ASSISTANCE IN THE ESTABLISHMENT OF
A PESTICIDES PRODUCTION AND FORMULATION PLANT

SI/URT/86/875

Technical report: Construction of Chemical Plants*

Based on the work of Rajinder N. Juneja,
expert in construction of chemical plants

REVISED LAYOUT

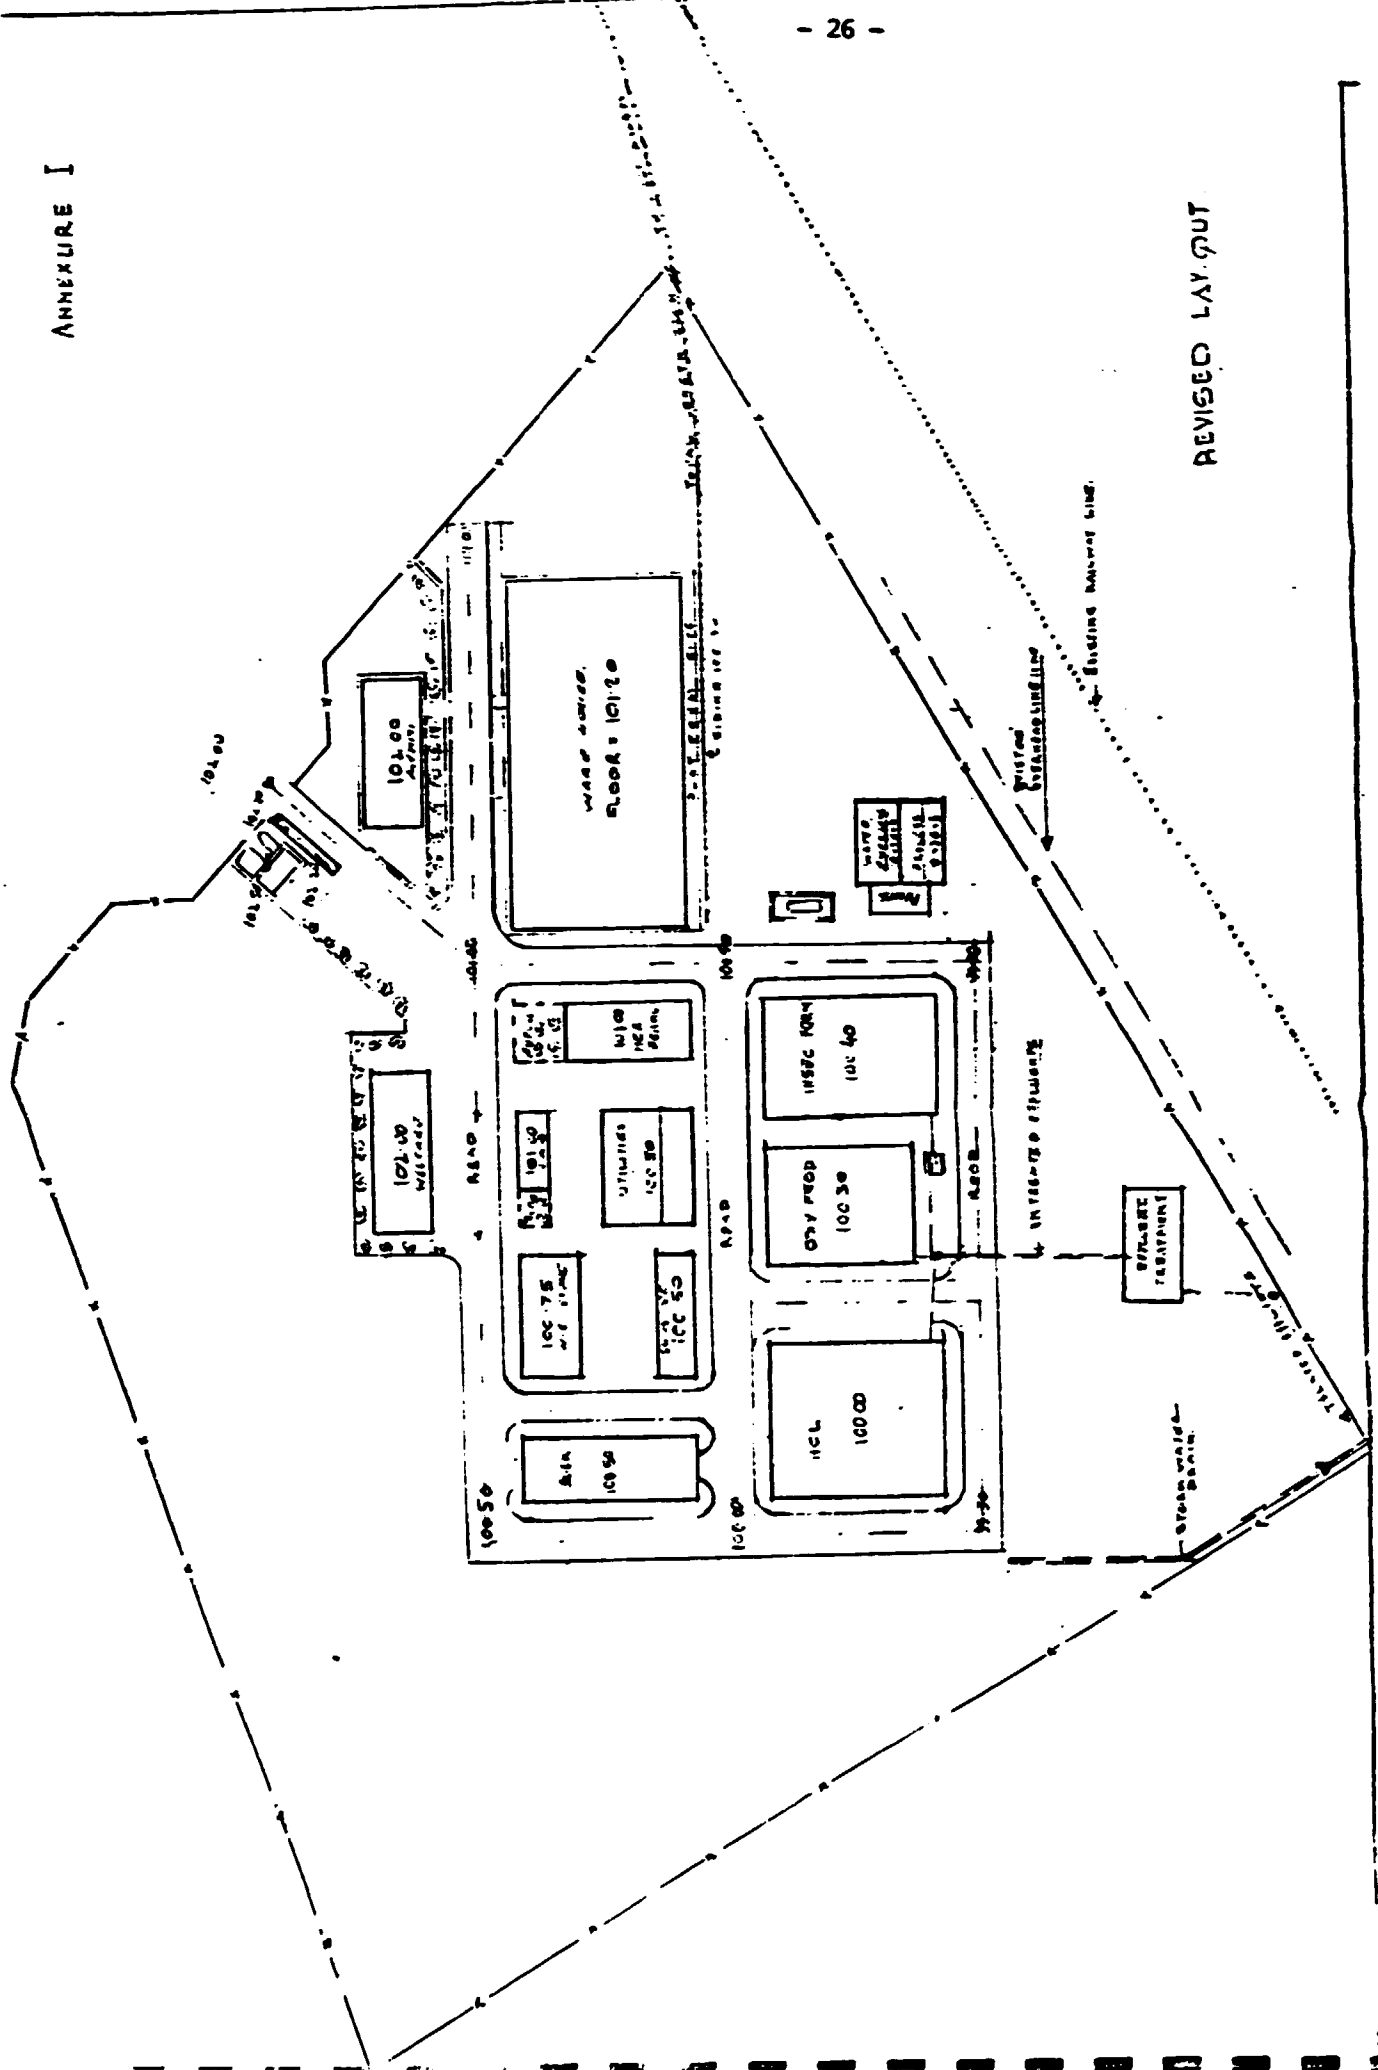
- The oxychloride production building bearing serial No.6 in the layout drawing has been located in the centre of the southern wing of plant buildings. The raw materials are to be brought from bulk storage godown located sufficiently far off. The product is then to be taken to the formulation buildings No. 5 located on its western side. The packing material is to be brought from warehouse located in North East. Lastly the packed formulated material would be transported from South West End of the plant to warehouse located at North East End. This is against the norms of good layout.

- The Hcl production plant has been located between the contour 100.00 and 101.00. The floor level proposed is 100.00. This plant has got two numbers of pits near contour 101.00. The size of one pit is 5 x 5m and this will have to be excavated up to level 96.20. The second pit having size of 7m x 7m will be excavated up to level of 96.70. From the design information report submitted by M/S M.K.C.E., gryish romb porphy was found to occur at depth of between 2.0 and 2.2 metres in all cases. In this case the rock would approximately be available at 98.50 level. Thus the excavation in these pits would involve rock cutting of 1.80m to 2.30m depth.

- The sewers carrying the acidic effluent from this plant are crossing all other underground ducts like power cables, water main and storm water drains etc. Therefore its location needs to be changed.

To overcome the above situation it is proposed to follow the natural contours and maintain the Road and Storm water drain levels accordingly. The levels as proposed have been mentioned on the sketch at Annexure (I). The summary is as under:-

- The Roads between warehouse and Admn. and in front of welfare block, starting from Eastern End to Western End would be laid at 101.00 level which is the natural Ground level.

- The Central Road would be at 100.20 level, matching to the existing ground levels.
- The Southern road would be 99.75 on Eastern End and 99.50 level on Western End. This would involve filling of 0.50m only.

The other plant buildings would need minor changes in floor levels, and the same have been marked over the site plan in Annexure 1.

The treated effluents from these cess pools could be taken away by trucks of Municipal Council. This system is prevalent in this country. The location of these septic tanks has been marked in the layout plan at Annexure I.

A fresh layout has been prepared, (Ref. Annexure I). In this drawing all the above points have been considered like, the flow of raw material inputs and finished goods and their transport to warehouse has been maintained. The Hcl plant has been located at South West end between contours of 99 and 100. Thus there will be a very small quantity of rock in excavating the pits which is clear from the data:-

SKETCH SHOWING THE RAMPS, PLATFORM AND ALY SIDING INCLUDING WAREHOUSE LEVELS

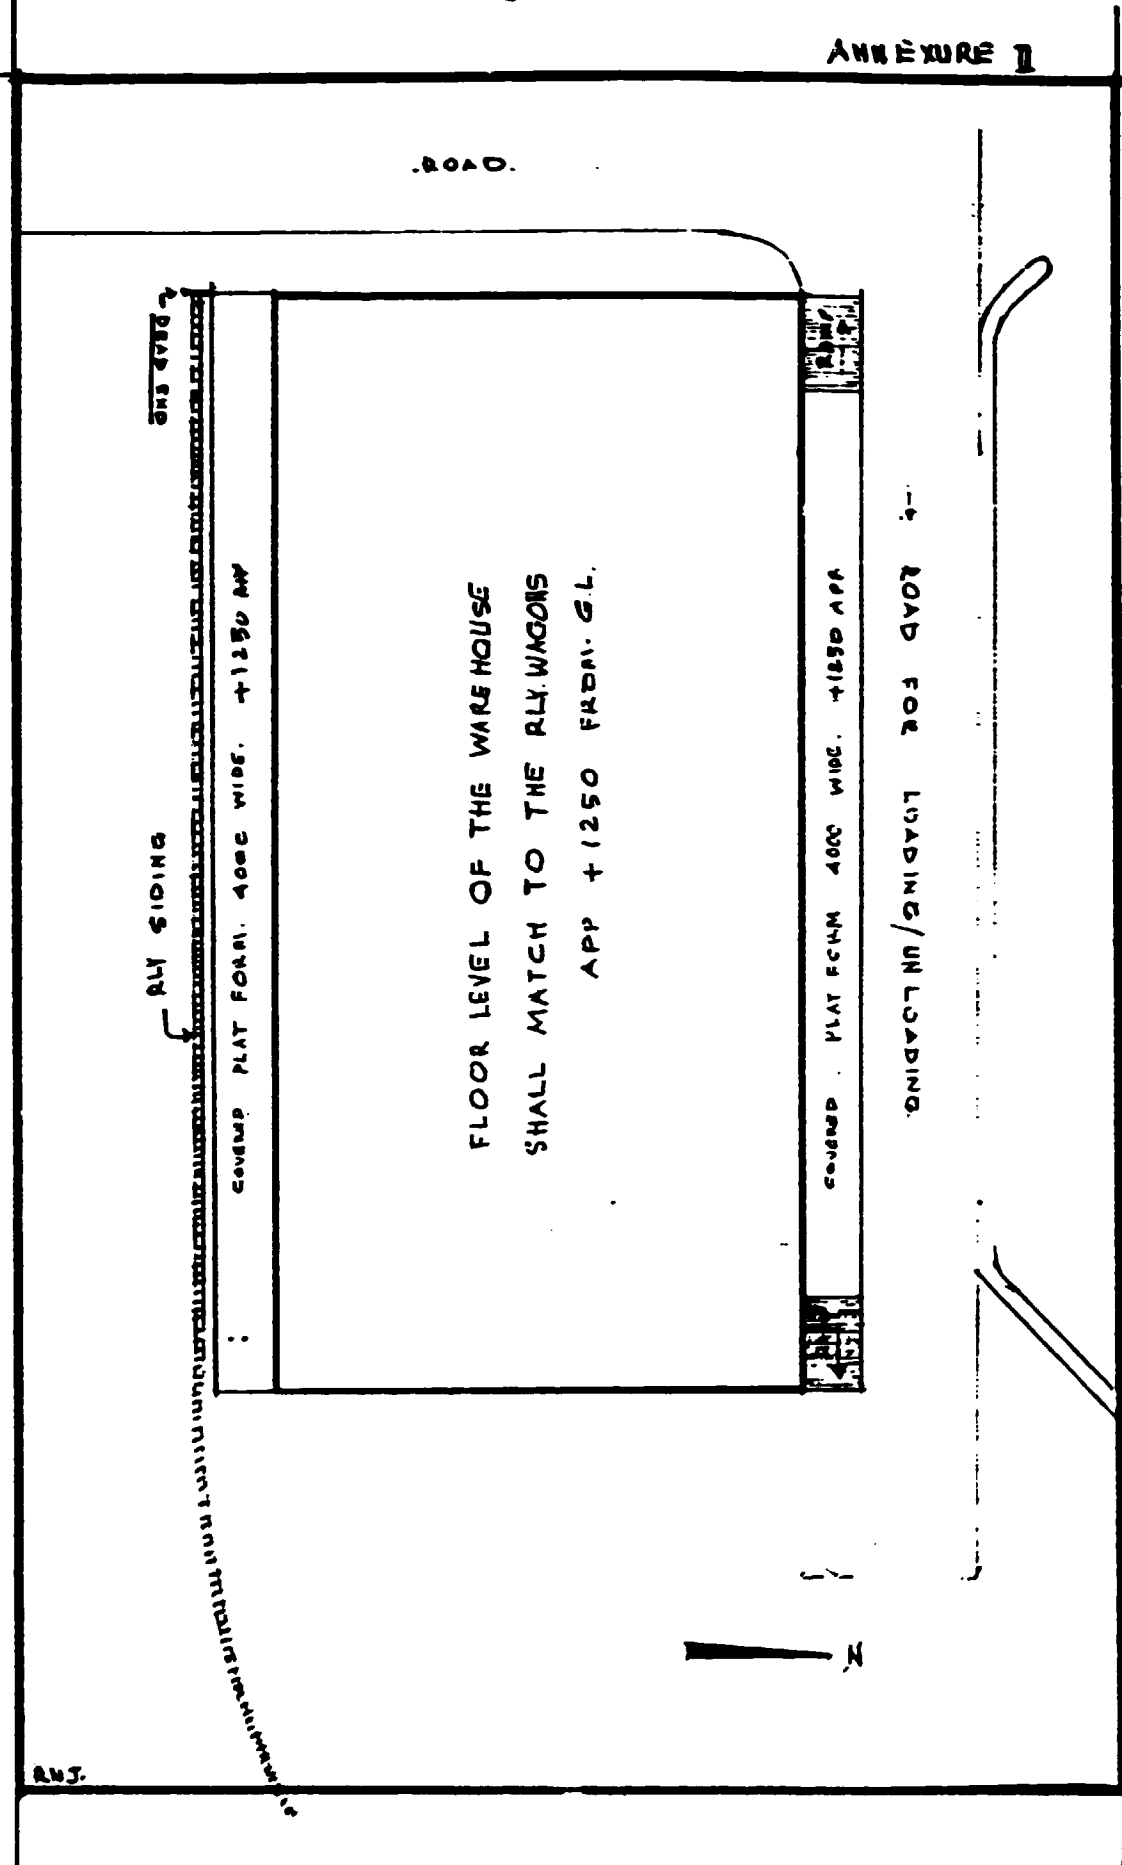
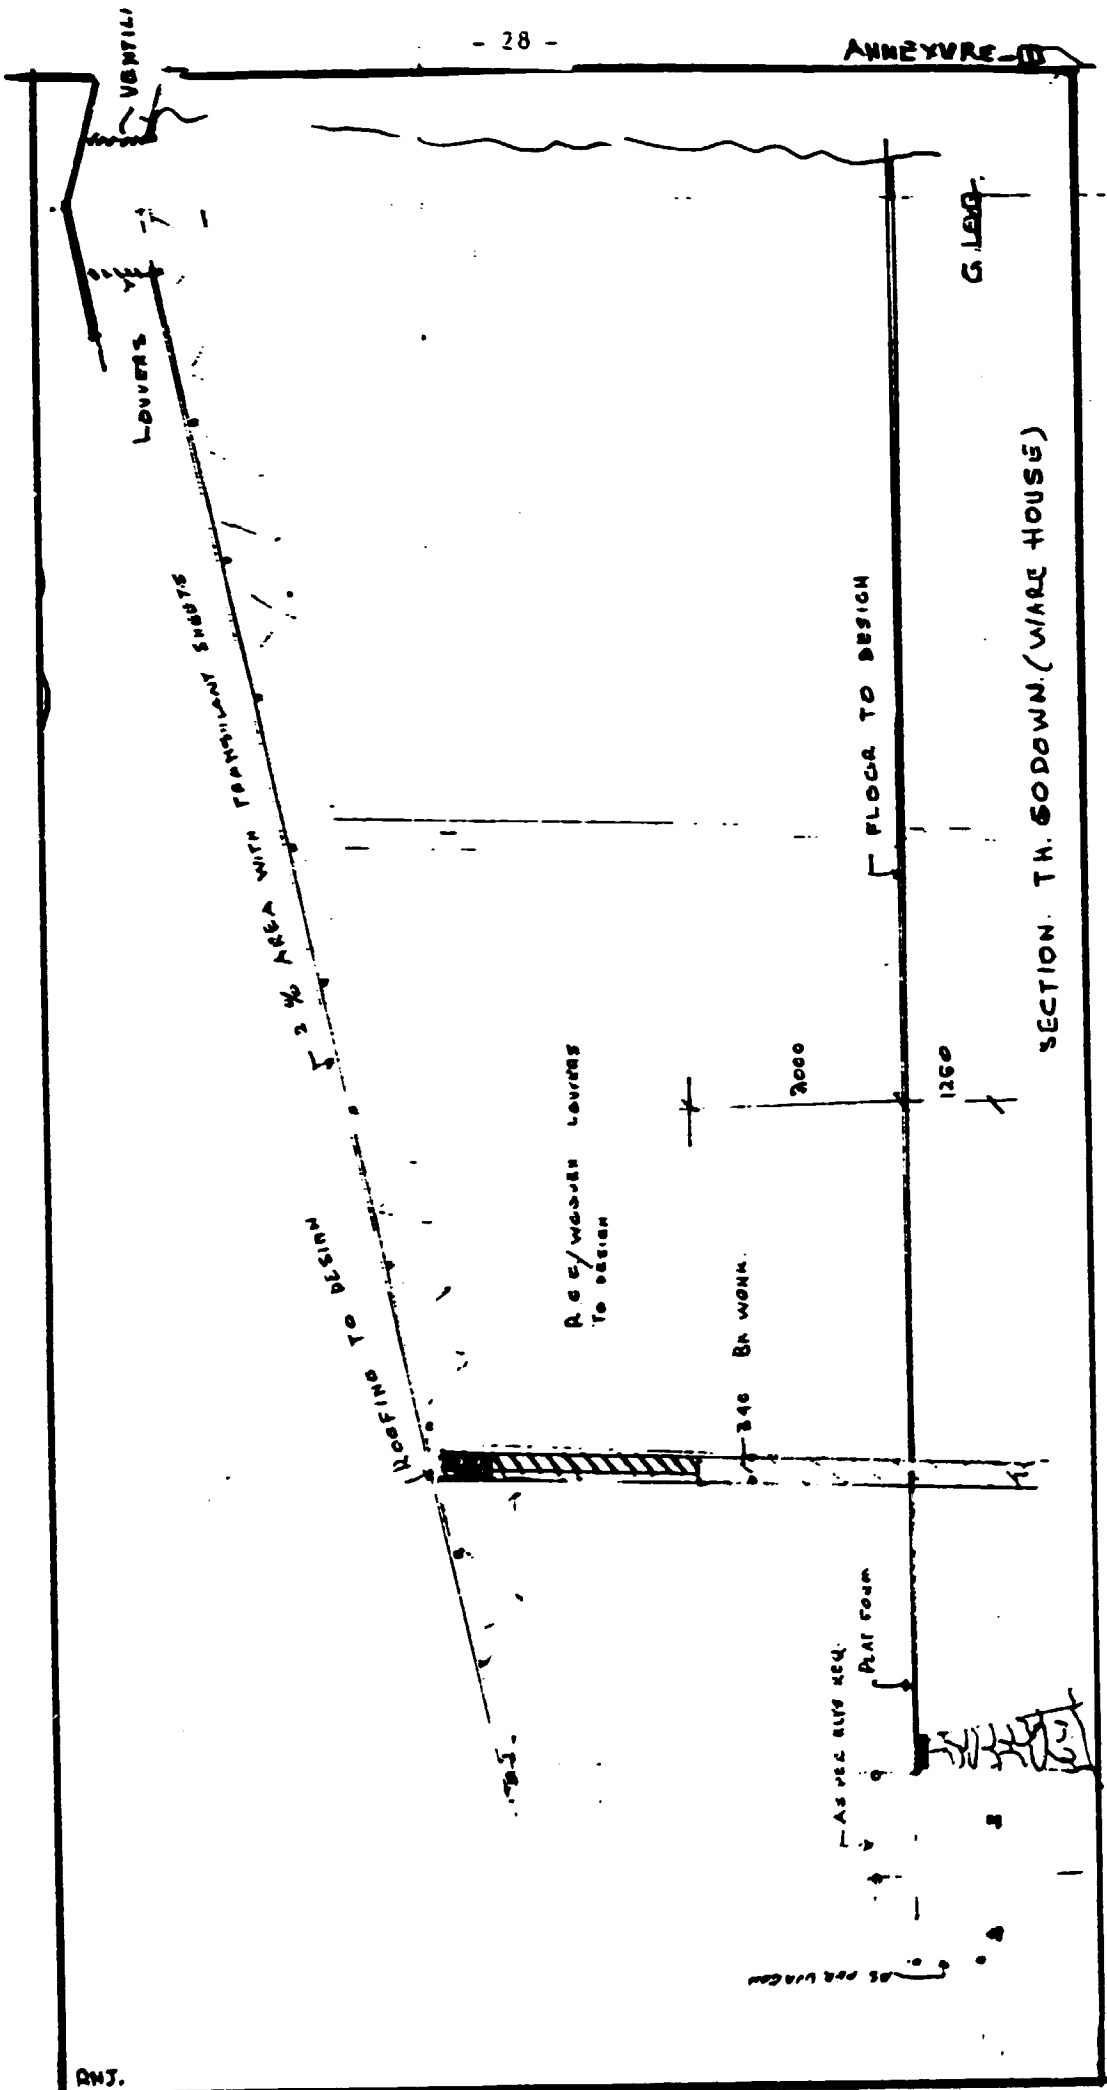
8.2 There will be some changes in other buildings. The level of the road on Northern side of the warehouse is 101.00 hence the floor level would be 101.20. This change would not only reduce excavation of the area, but would also facilitate the construction of platform for Rly Siding, where the ground level is 100.00. The platform is supposed to be 1m higher than the ground level.

ADMINISTRATION BLOCK AND SALES OFFICE: 27.23 X 12 - 327 M²

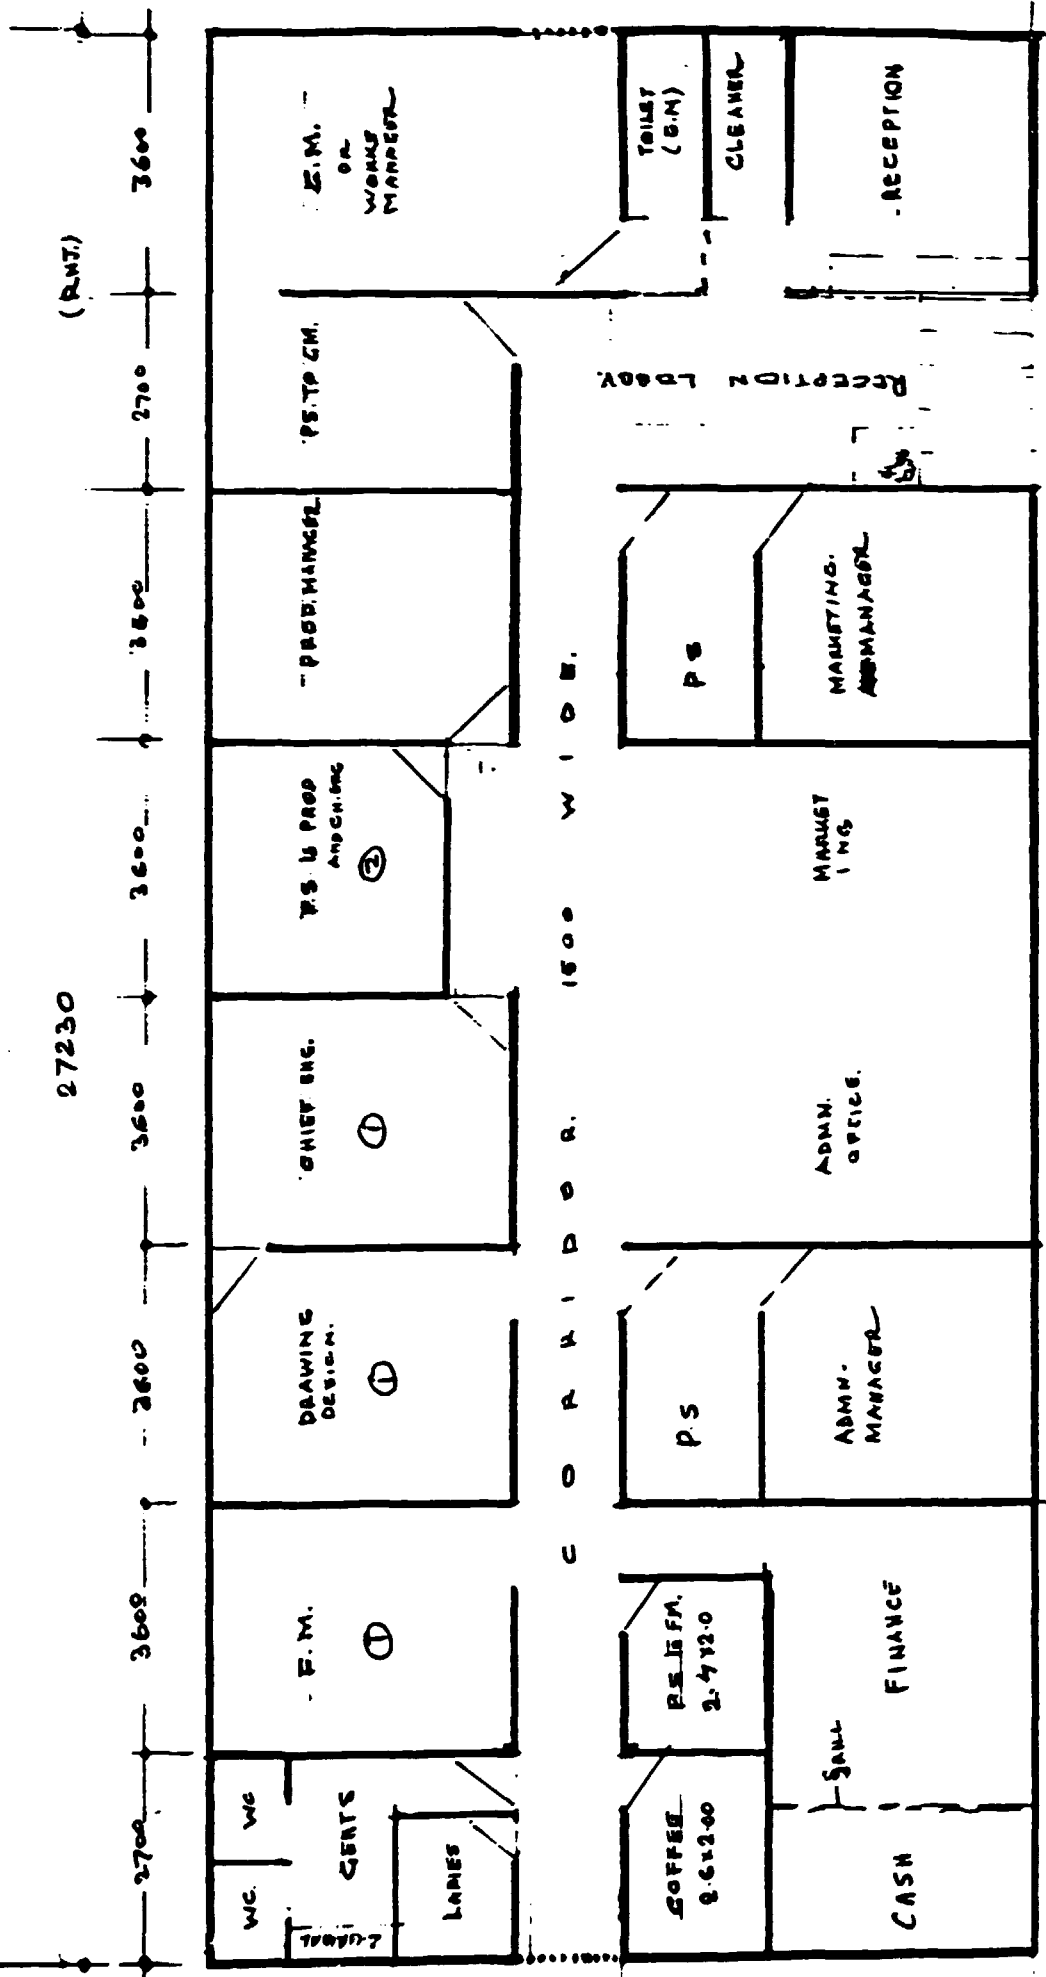
This building would accommodate about 26 employees including General Manager, functional managers, their private secretaries, supervisory and clerical staff, toilets, reception, drawing office and coffee room etc. The details of area requirement have been worked at as under:-

- GM's office with toilet	=	25	m ²
- Managers - 5 x 15	=	75	m ²
- Supervisory and clerical staff 21 x 4.50	=	95	m ²
- Reception	=	10	m ²
- Drawing office/Record Room	=	15	m ²
- Toilets two for men and one for ladies - 3 x 4.50	=	13	m ²
- Cashier	=	8	m ²
- Coffee Room	=	5	m ²
- Cleaner	=	5	m ²
		<hr/>	
		251	m ²
		<hr/>	
Circulation Area 20%		50	m ²
Area occupied by walls 10%	=	301	
		30	m ²
		<hr/>	
Total	=	331	m ²
		<hr/>

Based on the above requirements a sketch drawing has been prepared and is attached at Annexure VII. The area proposed for this building is 327 sq.m.
